SERVICE BULLETIN

M-886

XL/XR SPROCKET NUT

Figure 2. Rib Cutout Location

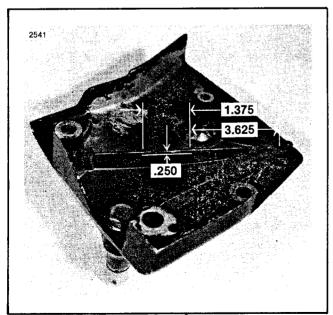
To use this nut on 1981 to early 1984 vehicles it will be necessary to remove a portion of the cover to prevent in-

terference between the nut and the cover. See Figure 2. On 1977 and 1978 vehicles having inner cover Part No. 34893-75, it is necessary to open up the .88 in. opening in the cover to 1.75 in. diameter, Figure 3. On 1979 models with inner cover, Part No. 34899-79, a 1.75 in. diameter hole must be located and drilled as shown in Figure 4.
